**Subject:** RE: New application post - NYM/2019/0629/NM Brickyard Cottage (formerly Rock Head), Robin Hood Road, Ravenscar - Parish

Job: Brickyard Cottage  
Address: Brickyard Cottage, Robin Hood Lane, Ravenscar, Scarborough YO13 0ES  
Client: Mr and Mrs Hollingworth

Job No.	Dwg no.	Sheet No.	Revision	Sheet Size
098	P05	01	B	A3

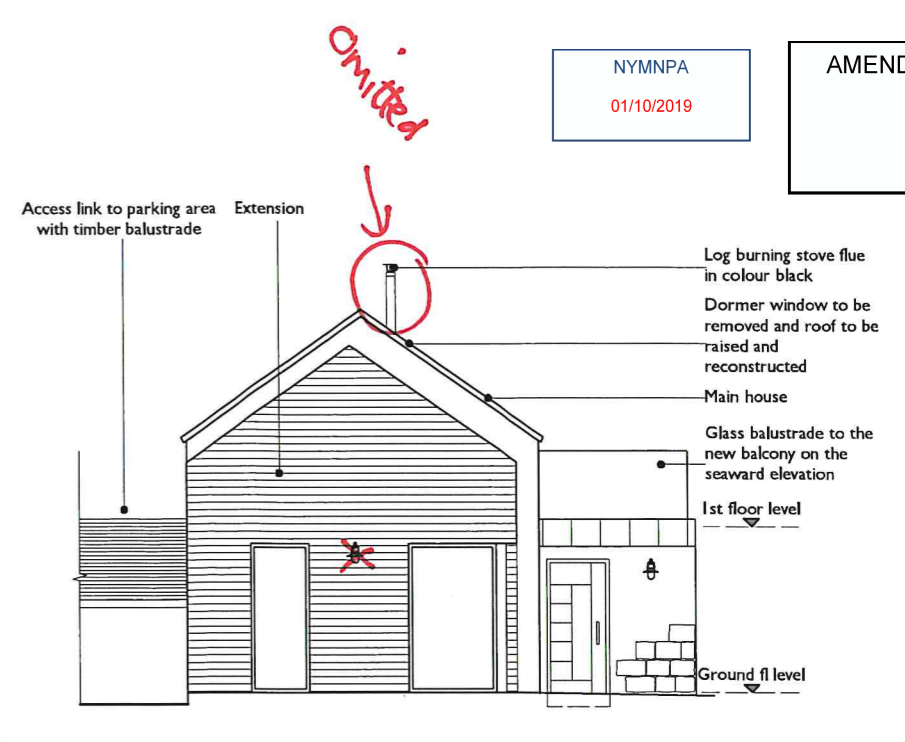
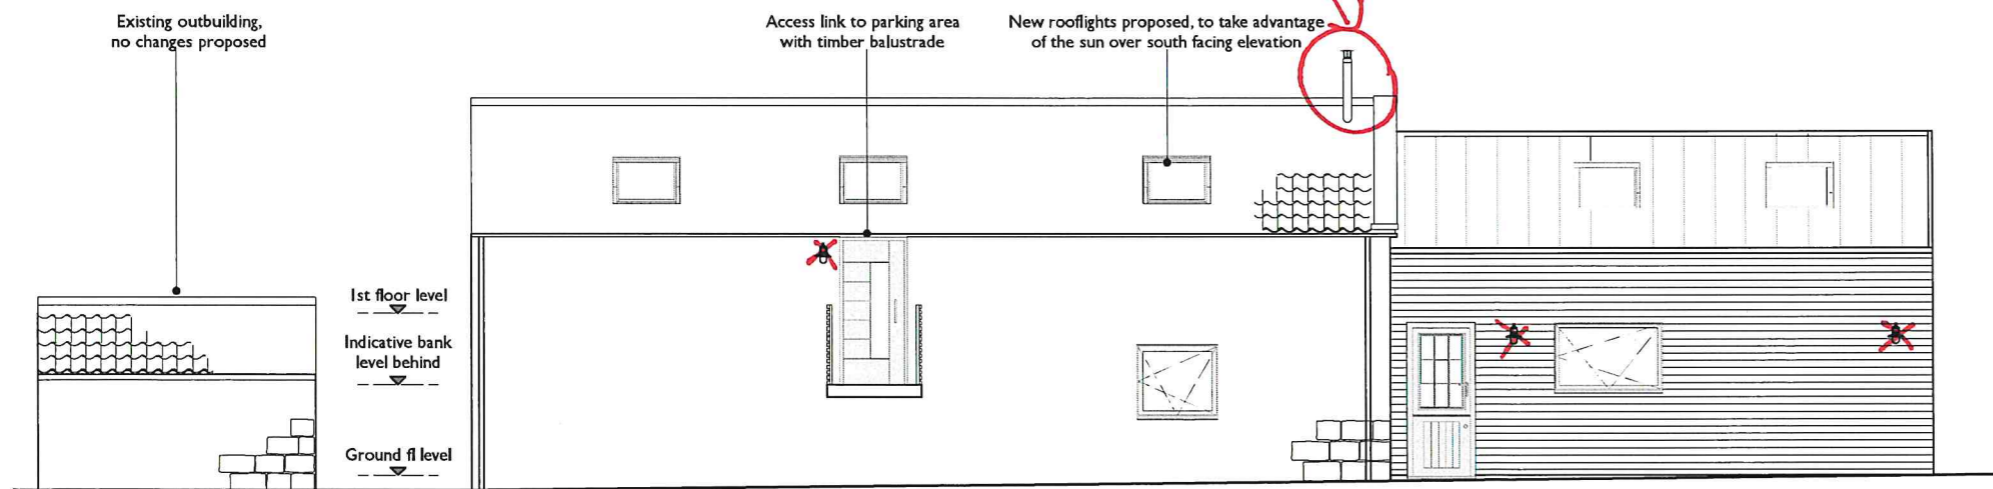
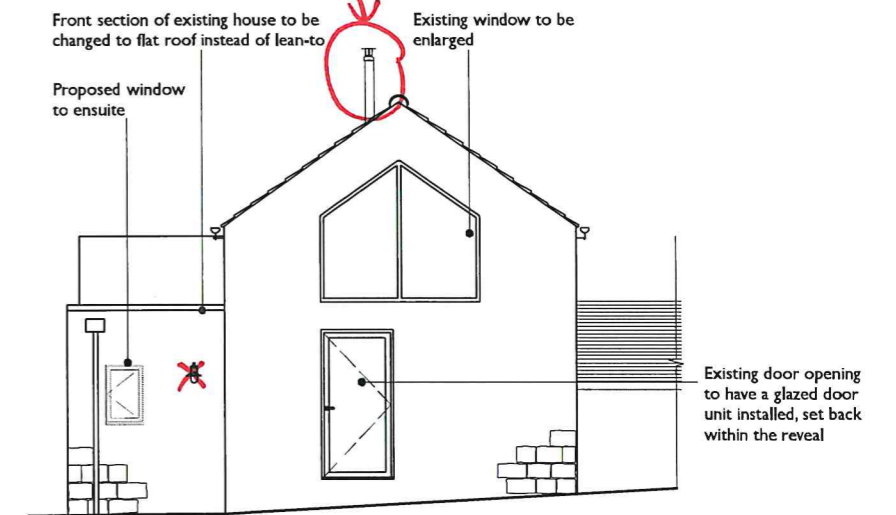
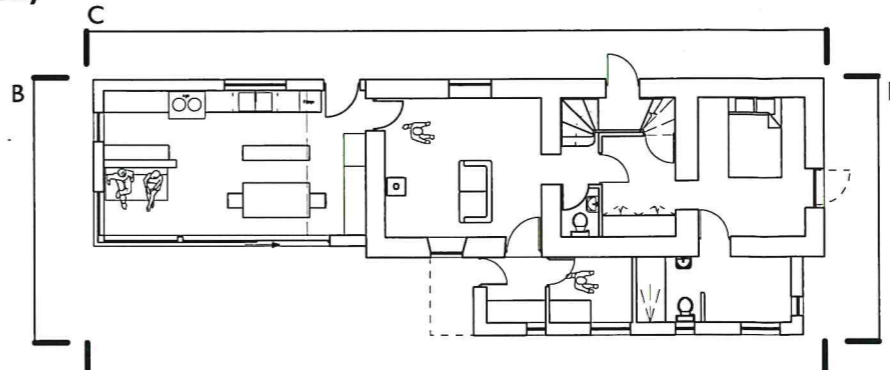
Many thanks Hilary – the client has agreed to omit the chimney from the plans and will revert back to the approved traditional chimney.

B 280818 SS Amendments incl: window added to Elevation D, rooflight added Elevation C, height of outbuilding corrected, rooflight sizes amended, Log burning stove flue instead of chimney, style of windows and doors amended, External lights added, External land levels amended to reflect topographical survey.  
A 040319 SS Amendments incl: decrease length of extension and reduced extension eaves, Changes to front single storey length and windows

**PART SUPERSEDED**  
2/10/2019,  
Notes: Flue removed.  
External lights not considered under this application but under 2019/0630/CVC
